CERTIFICATE OF APPROPRIATENESS APPLICATION

CITY OF SENECA, SOUTH CAROLINA

Staff Report

406 S Townville St

406 5. Townville St. Seneca BAR Review Attachment A B&W Rendering

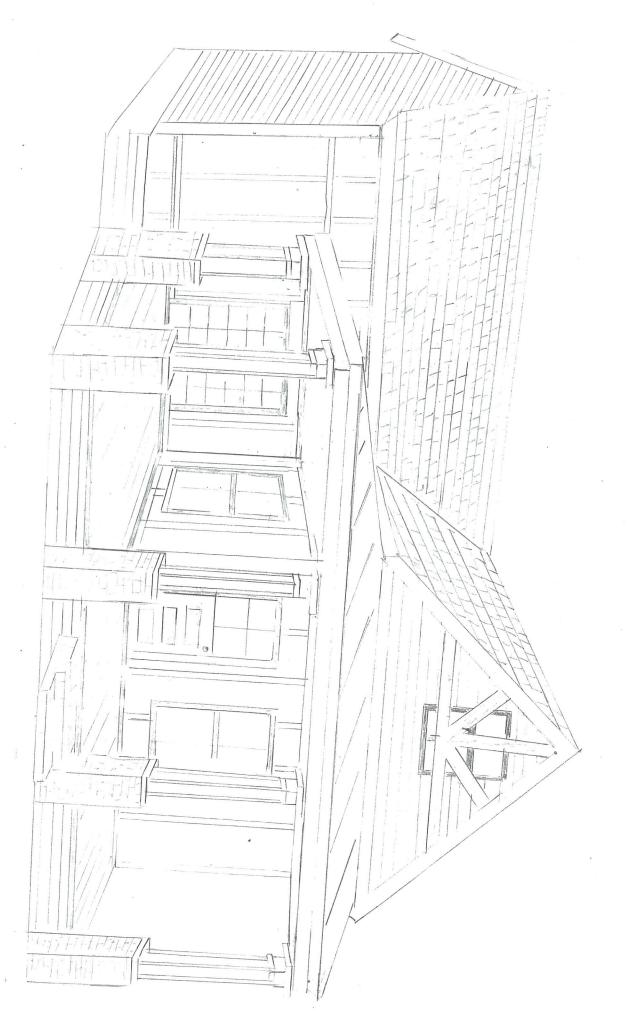
Section 2.05 (Architectural Character-Materials, Details, and Textures) states that decorative orientation shall not be removed or concealed and shall be compatible with buildings, and places to which it is visually related. The addition of exposed beams is in appropriate as it is not part of the design vernacular or the area. Beams are more appropriate for rustic or cabin designs and do not fit downtown Seneca. The addition obscures the window/light/vent area of the gable, such lights are common to the City of Seneca.

Section 201.1 (Roof) states that roof material should be compatible (in kind) material. Any metal roof material shall have earth tone and have a matte, non-reflective finish. Both existing roof and metal roof are deemed appropriate, the mixing of them on separate roof areas and pitches is also seen as acceptable.

406 3. Townville St. Seneca BAR Review Attachment OC: Column Detail

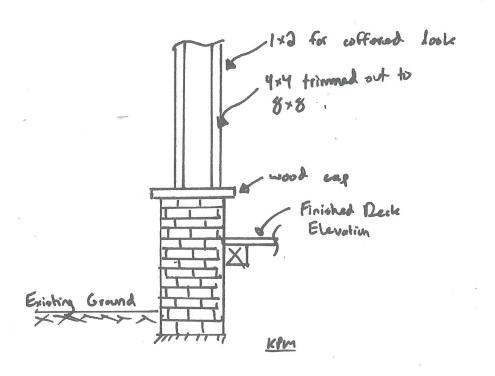
Section 2.03 (Columns and Railings) states material should be retained and repaired with materials to match the original. If repair is required, use like materials to match the original. Full brick, full wood columns, and combinations of wood over brick are all common in the downtown.
